Reference 22/2306/MRES

Proposal Application seeking approval of the reserved matters (access, appearance, landscaping, layout and scale) for the construction of 31 dwellings including affordable housing, parking, roads, footpaths, landscaping, open space, associated site infrastructure, and all other associated works (including ground modelling and utilities). This is a subsequent application in respect of outline permission 03/P1900 which was accompanied by an Environmental Statement and seeks the discharge of the relevant conditions of the outline permission (6, 11, 14, 17, 20, 22, 23, 24, 28, 36 and 37).

Reference 22/2354/MFUL

Committee Date: 23.09.2025
Cranbrook (Cranbrook)	22/2306/MRES & 22/2354/MFUL	Target Date: 16.02.2023 (22/2306/MRES) 10.02.2023 (22/2354/MFUL)
Applicant:	22/2306/MRES – East Devon Community Partners. 22/2354/MFUL – Persimmon Homes South West.	
Location:	Parcels Tc5a, Tc6 & Tc7a, Tillhouse Road, Cranbrook.	
Proposal:	<p>22/2306/MRES - Application seeking approval of the reserved matters (access, appearance, landscaping, layout and scale) for the construction of 31 dwellings including affordable housing, parking, roads, footpaths, landscaping, open space,

Appendix 1. Map of Landscaped Character Areas superimposed with the combined inner/middle consultation zones and outer consultation zones of the major accident hazard pipeline.

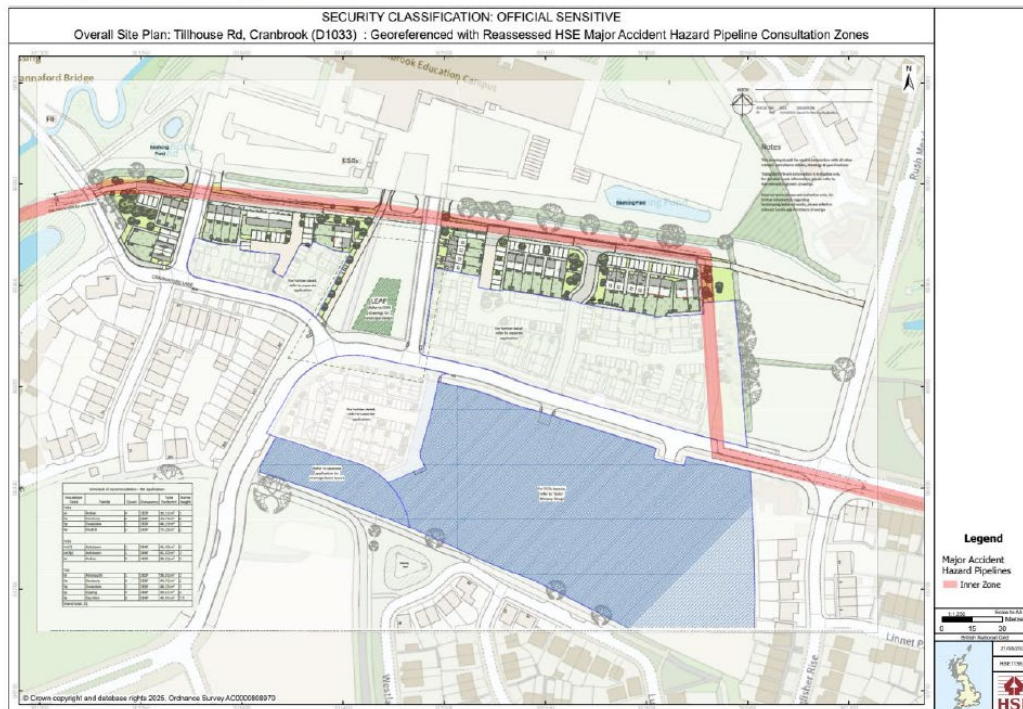
5. In summary HSE's Land Use Planning advice team **does not advise**, on safety grounds, against the granting of planning permission.

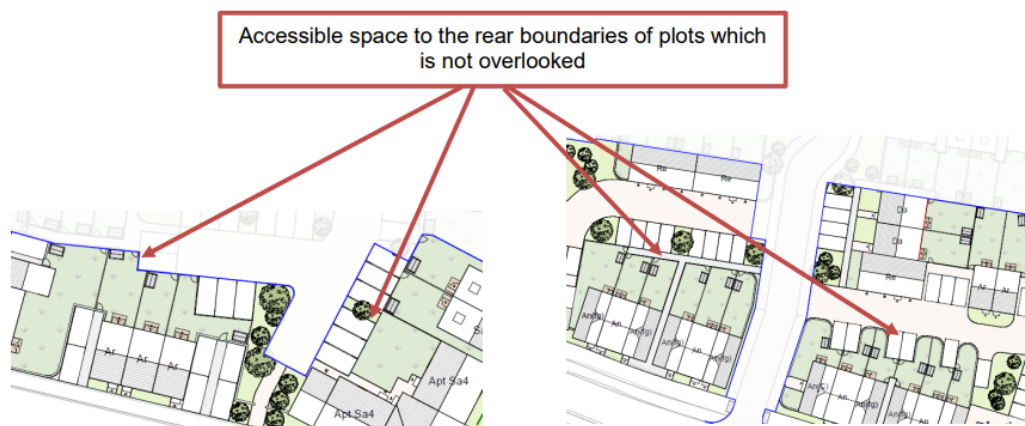
We note Parcel TC5a and Tc7a will not providing any affordable housing.

Parcel TC6 will provide 3 affordable units. These will be 2 bedroom, 4 person houses, which we support. We require the tenure to be Social Rent as this meets housing need in the district and aligns with government priorities for the delivery of new affordable housing.

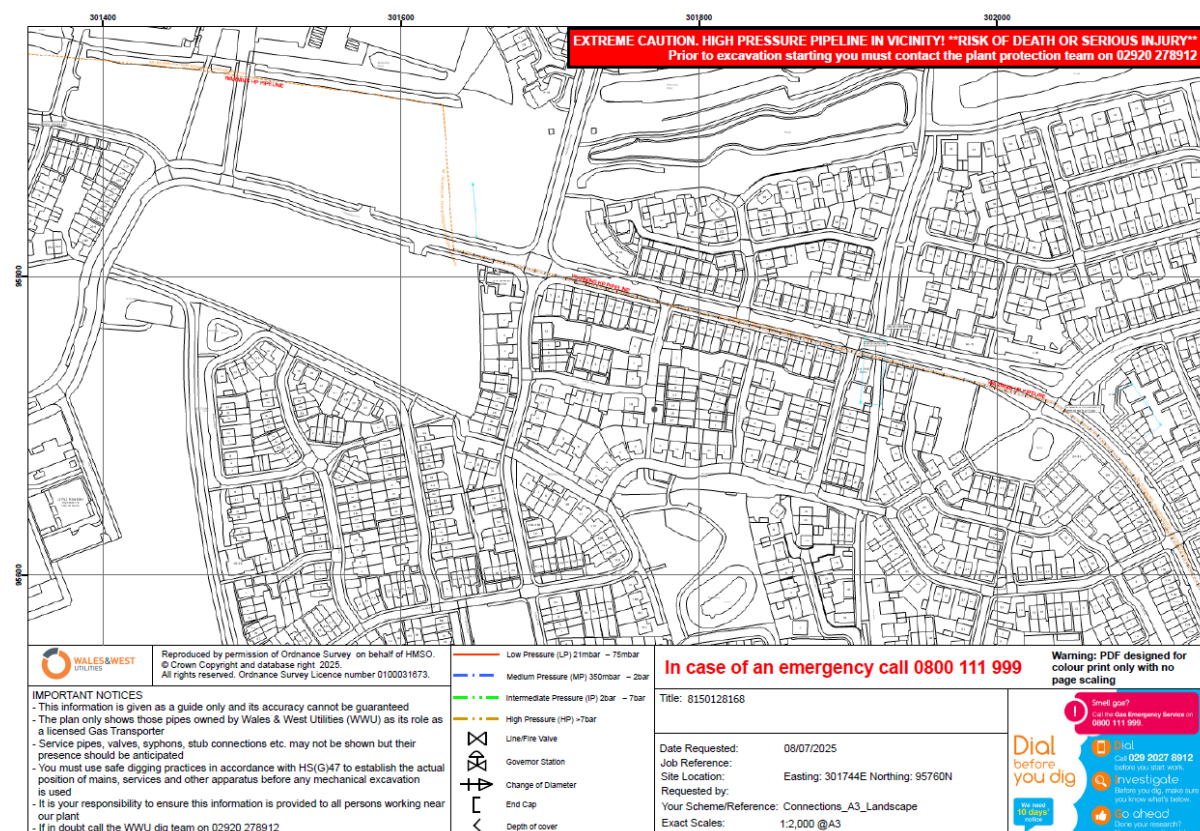
- There is no drawing to demonstrate how the western apartments on 7a relate to the existing housing opposite. It could contrast or conform with this but needs to demonstrate a design approach that helps to create a built scale and attractive, memorable townscape appropriate to this entrance to the town centre (5, 6, 7; A, B, C, F)

- The view from the Crannaford lane is not well terminated. The apartment building on 7a opposite the junction is offset when it should be central and does not present a vibrant or attractive elevation towards this Cranbrook entrance (5, 6, 7, 8; B, D, F)

- The 7a apartment facing north has been located to be central in the view from the school but the elevation is austere, there is no private outdoor space around its perimeter and the lack of private entrances results in a relatively lifeless street scene (4, 6, 7, 8, 9; B, C, F, H)

- It would be better to have housing facing onto the basin across the southern boundary of 7a rather than having a gap onto parking and access road. A pedestrian link should be retained but designed to be attractive and clearly overlooked from inhabited rooms (1, 2, 4, 5, 6, 7, 8, 9; A, D)
- Units 93-94 share the same issue as so many others by sitting in a sea of SLOAP. Much of this could be incorporated into private garden space, used as part of the SuDS chain or designed as social space rather than being simply left in front of people's homes for no apparent reason (4, 5, 6, 7, 11, 12; B, E, F, H)
